## **Technical News Bulletin**

Steinhausen, July 1996

# NNPB Plunger Positioner For DG 5 ½" & DG 6 ¼"

Fig. 1: NNPB Plunger Positioner 62-404 Gr. 9

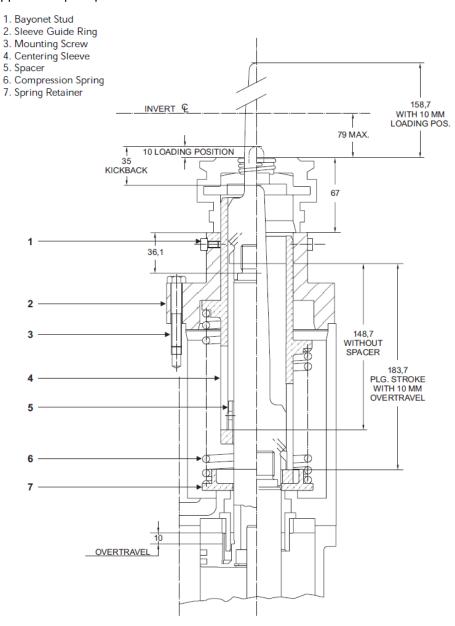
The new NNPB Plunger Positioner 62-404 Gr. 9 (Fig. 1) exhibits several design features such as:

- Reduced "kick-back" for optimum plunger loading position and increased plunger length.
- Single piece sleeve guide ring with extended bore length for precise centering sleeve guidance. Prevents sleeve jamming in the Down position.
- Sleeve guide ring provided with studs for bayonet type retainer for locking the centering sleeve in the Down position for plunger exchange when a split ring attachment is used.
- · Hexagon head mounting screws for easier positioner assembly or disassembly.
